Re: Babcock Road 165 (Amendment)

MDP # 827-A

The City Staff Development Review Committee has reviewed the Babcock Road 165 (Amendment) Master Development Plan **MDP# 827-A (Amendment)**. Please find enclosed a signed copy for your files. Your plan was approved for acceptance, however, please note the following conditions:

BABCOCK ROAD 165
AMENDED
MASTER DEVELOPMENT PLAN (MDP)

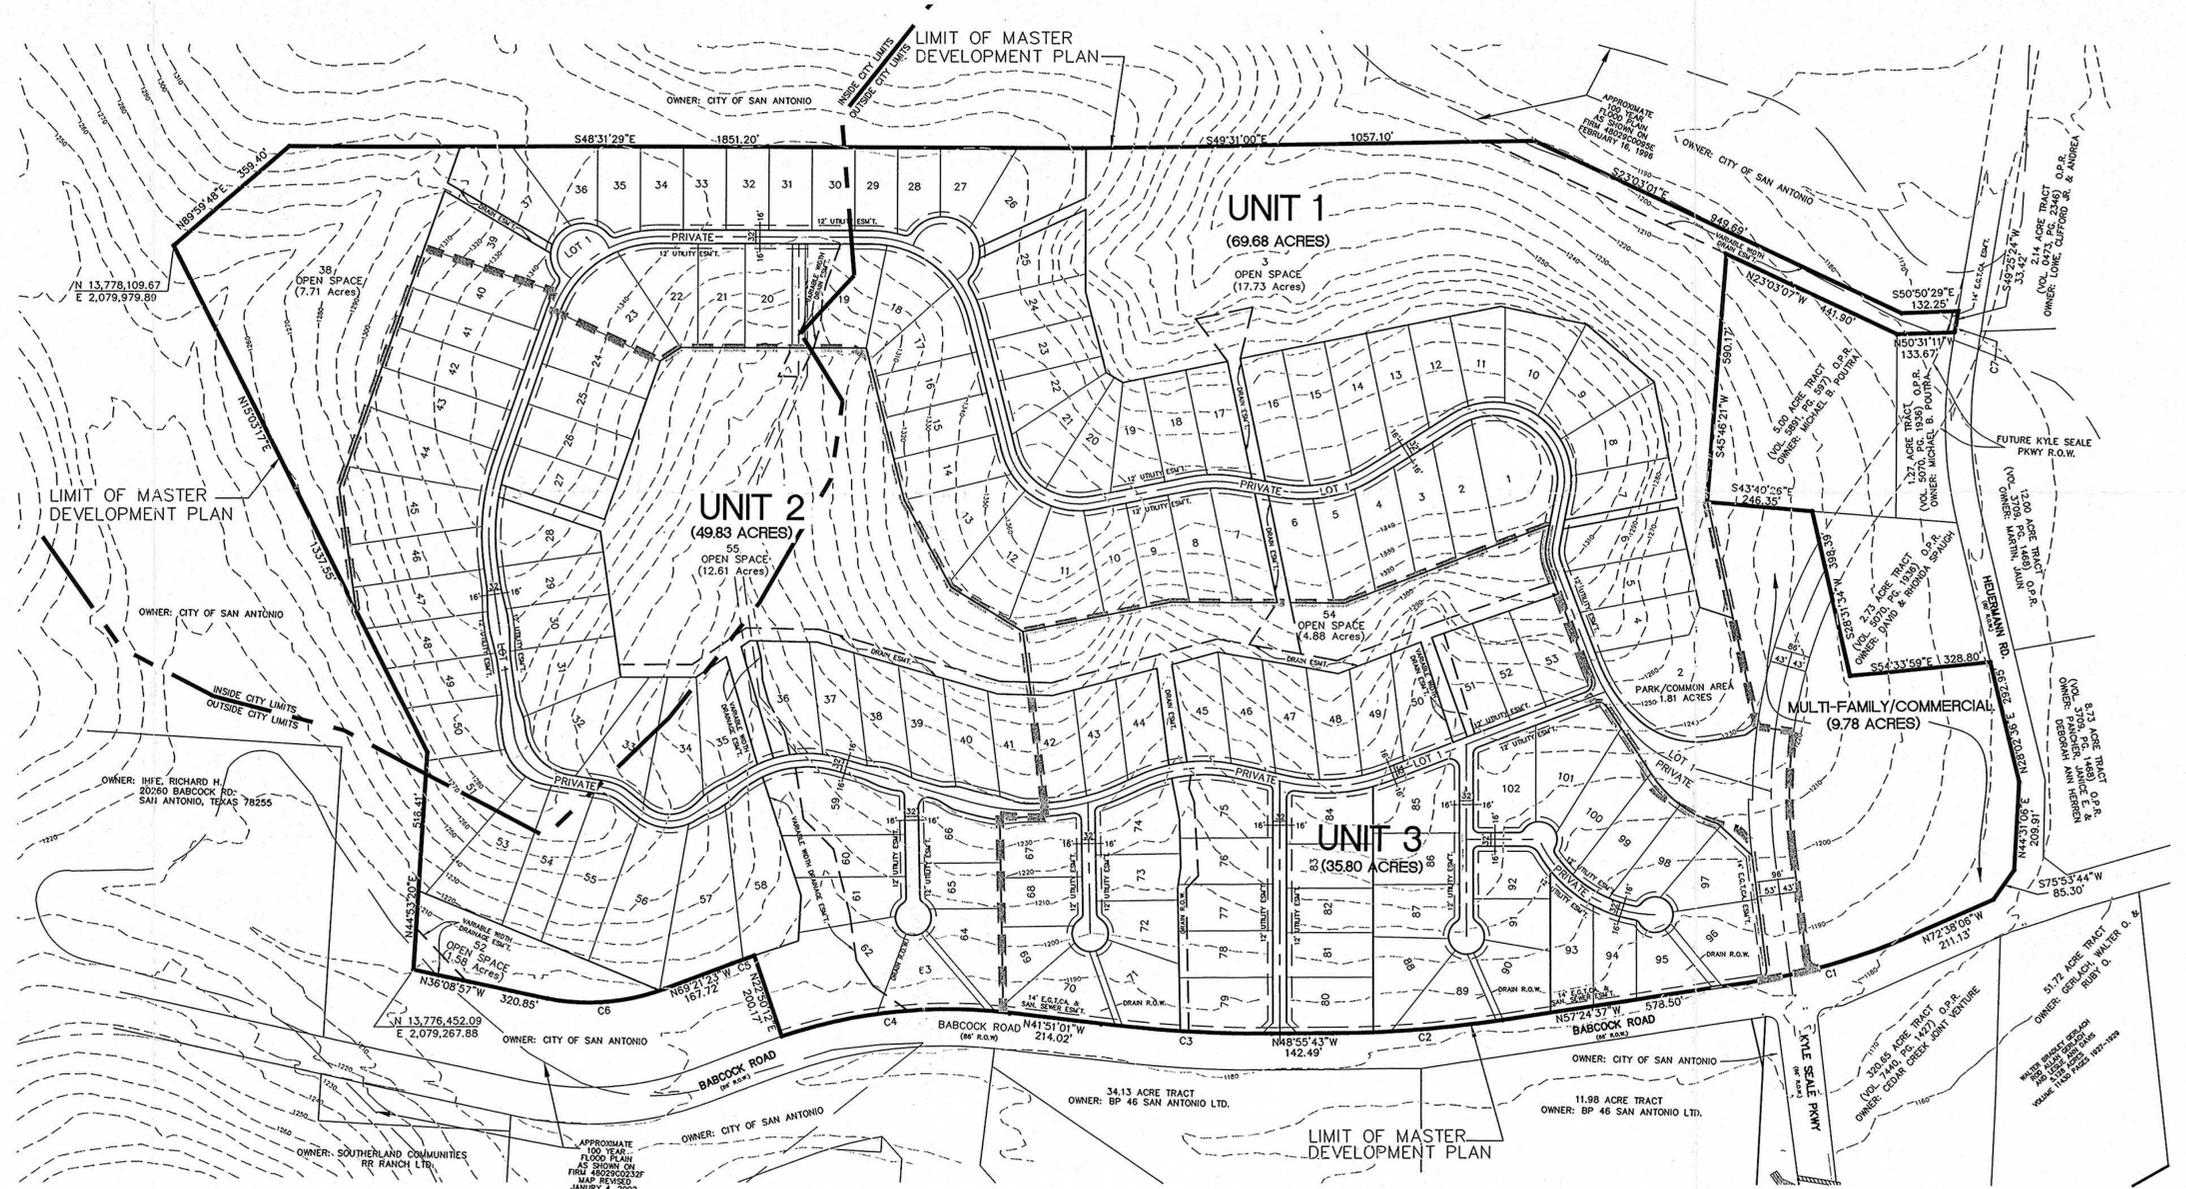
In consideration of public safety and convenience, excessive grades by reason of topography should be avoided in street layouts and arrangements. Any access and right-of-way issues along state facilities will need to be resolved with the **Texas Department of Transportation (TxDOT)**. For information about these requirements you can contact TxDOT at (210) 615-5814.

1. Dedicate and construct Kyle Seale Parkway as a secondary arterial type "A" four lane divided roadway, within the limits of this MDP.
2. Provide a minimum of 100-foot queue storage for the residential entrance from Kyle Seale.
3. A median opening on Kyle Seale Parkway will be allowed 480 feet east of Babcock for the residential access. However, if traffic demand for the westbound Kyle Seale Parkway creates queuing problems in the future due to the proximity of residential entrance to Babcock, the median opening may be closed.
4. The developer shall coordinate with Jim Brannan, P.E. (210-335-6711) at Bexar County for the extension of Kyle Seale Parkway due to a current Capital Improvement Project on Babcock Road .

It is understood that this MDP is a conceptual plan and controlled access should be maintained in order to uphold safe and efficient traffic flow. Therefore, the developer of this property is encouraged to design common access and shared driveways between all proposed commercial or multi-family lots. Bexar County reserves the right to address driveways, street design, sight distance, ADA requirements, drainage, and floodplain issues at time of platting.
